**BELLEFONTE COMBINED LICENSE APPLICATION – RESPONSE TO ENVIRONMENTAL REPORT REQUEST FOR ADDITIONAL INFORMATION – CORMIX-RELATED HYDROLOGY INFORMATION**

Responses to Environmental Report Requests for Additional Information –  
CORMIX-Related Hydrology Information

**NRC RAI NUMBER: 5.2-5, 5.3-3(2), 5.3-3(3), 5.3-5, and 5.3-8**

**NRC RAI NUMBER: 5.3-2 and 5.3-3 (1)**

ATTACHMENT 5.3-3(1)A  
TENNESSEE VALLEY AUTHORITY  
FLOW FREQUENCY PERCENTAGE FOR FLOW PAST THE BLN

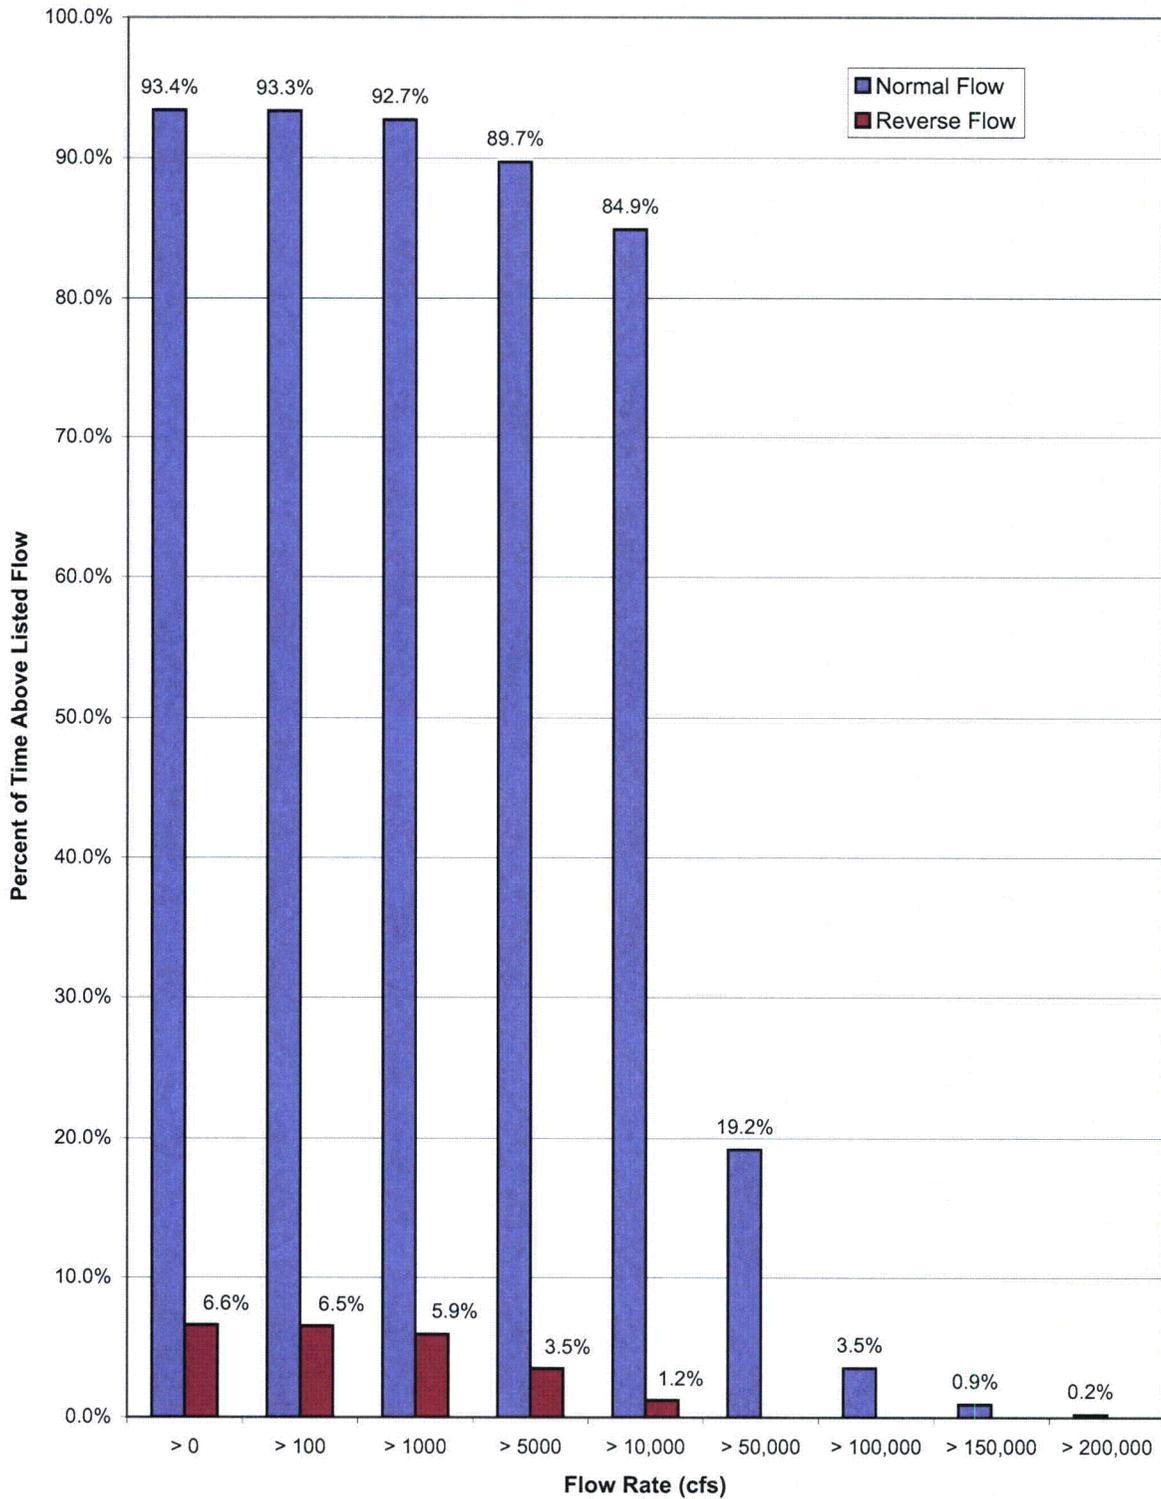
- 5.3-2:** (1) Provide the CORMIX output files for the ER Rev0 CORMIX analyses.
- (2) Provide a description and data associated with definition of “reversing river flow”, and “maximum reverse river flow”, e.g., the river discharge values employed in the analyses.
- 5.3-3:** (1) Provide data or an analysis of flow reversal at the Bellefonte site that better characterizes the flow reversal phenomena. Use the existing reservoir operation rules and any future anticipated changes to peaking strategy to evaluate these phenomena.

- 5.3-2:** *PNNL explained that in response to this RAI they need the description and data associated with improved or clarified definition of the three flow regimes that are key to understanding the reservoir response to the proposed discharge. This request for CORMIX input files and output summaries is related to the request documented in RAI 5.3-3 item (3), and the response to these two RAIs can be tied together.*

The percentage of time exceeding specific flow rates is shown in Attachment 5.3-3(1)A. Normal river flow direction was shown to occur approximately 93 percent of the time, with flow exceeding 10,000 cfs (normal) approximately 85 percent of the time. Reverse river flow direction was shown approximately 7 percent of the time, with flow exceeding 1000 cfs (reverse) approximately 6 percent of the time.

FIGURE 5.3-3  
100% EFFLUENT FLOW THROUGH BOTH  
DIFFUSERS - 7Q10 RIVER FLOW (39.2°F)

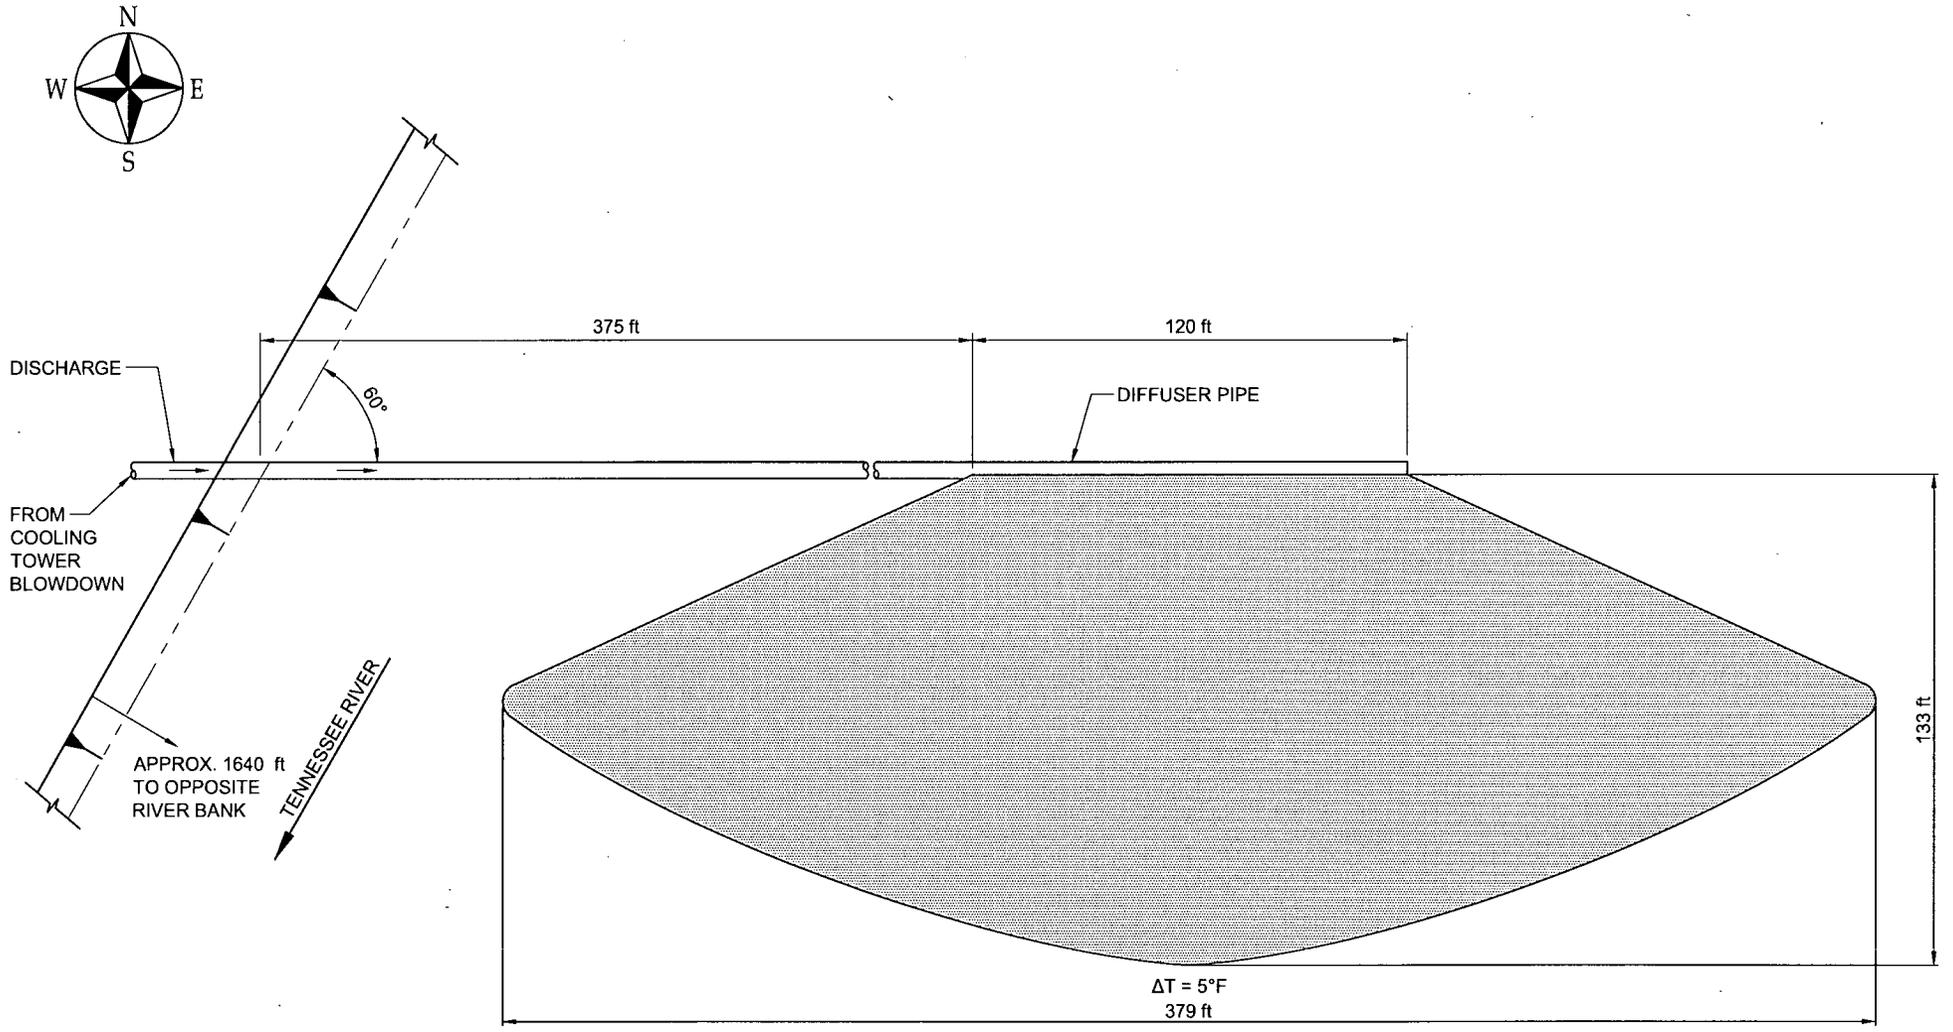
- 5.2-5:** Provide a description of all nine CORMIX cases analyzed to understand the potential impact of discharge on the Tennessee River.
- 5.3-3:** (2) If results of the flow reversal warrant them, provide revised descriptions of the CORMIX runs that characterize the operation of the diffusers.
- (3) If additional CORMIX simulations are conducted, provide their input and output files.
- 5.3-5:** (1) Review and revise Figures 5.3-3 through 5.3-11; for clarity, draw them all to scale or none to scale.
- (2) For these figures, use a consistent unit convention (English or Metric).
- 5.3-8:** Provide a referenceable, consistent, and complete discussion of the analysis and assumptions leading to the single pipe simulation (including the results of such simulation(s) appearing in the ER) for diffuser operation.

- 5.2-5:** *"During the discussion Charley confirmed that the RAI summary is correct and that we need the description and data associated with an improved or clarified definition of the three flow regimes that are key to understanding the reservoir response to the proposed discharge. We need the CORMIX input files and output summaries as described in RAI 5.3-3 item (3), and they need to be docketed in response to RAI 5.2-5 or 5.3-3 as these are related requests."*
- 5.3-3:** *"The discussion of RAI 5.2-5 and 5.3-2 during the conference call are related to this RAI as well and that relationship is indicated in the conference call summary included in those portions of the table."*

- Low river temperature, 7Q10 downstream flow (Figure 5.3-3)
- High river temperature, 7Q10 downstream flow (Figure 5.3-4)
- Low river temperature, reversing river flow \*
- High river temperature, reversing river flow \*
- Low river temperature, maximum reverse river flow (Figure 5.3- 5)
- High river temperature, maximum reverse river flow \*
- Low river temperature, maximum downstream flow \*
- High river temperature, maximum downstream flow \*

- Low river temperature, 7Q10 downstream flow (Figure 5.3-3)
- ~~Mean river temperature, 7Q10 downstream flow (Figure 5.3-4)~~
- High river temperature, 7Q10 downstream flow (Figure ~~5.3-5~~ 5.3-4)
- Low river temperature, reversing river flow (Figure ~~5.3-6~~ 5.3-5) \*
- ~~Mean river temperature, reversing river flow (Figure 5.3-7)~~
- High river temperature, reversing river flow (Figure ~~5.3-8~~ 5.3-5) \*
- Low river temperature, maximum reverse river flow (Figure ~~5.3-9~~ 5.3-5)
- ~~Mean river temperature, maximum reverse river flow (Figure 5.3-10)~~
- High river temperature, maximum reverse river flow (Figure ~~5.3-11~~ 5.3-5) \*
- Low river temperature, maximum downstream flow \*
- High river temperature, maximum downstream flow \*

7. Change COLA Part 3, ER Chapter 5, by **replacing existing** Figure 5.3-3, Rev. 0, **with Figure 5.3-3, Rev. 1**, 100% Effluent Flow through Both Diffusers – 7Q10 River Flow (39.2°F), provided as Attachment 5.3-5A.
8. Change COLA Part 3, ER Chapter 5, by **replacing existing** Figure 5.3-4, Rev. 0, **with Figure 5.3-4, Rev. 1**, 100% Effluent Flow through Both Diffusers – 7Q10 River Flow (90°F), provided as Attachment 5.3-5B.
9. Change COLA Part 3, ER Chapter 5, by **replacing existing** Figure 5.3-5, Rev. 0, **with Figure 5.3-5, Rev. 1**, 100% Effluent Flow through Both Diffusers – Maximum Reverse River Flow (39.2°F), provided as Attachment 5.3-5C.
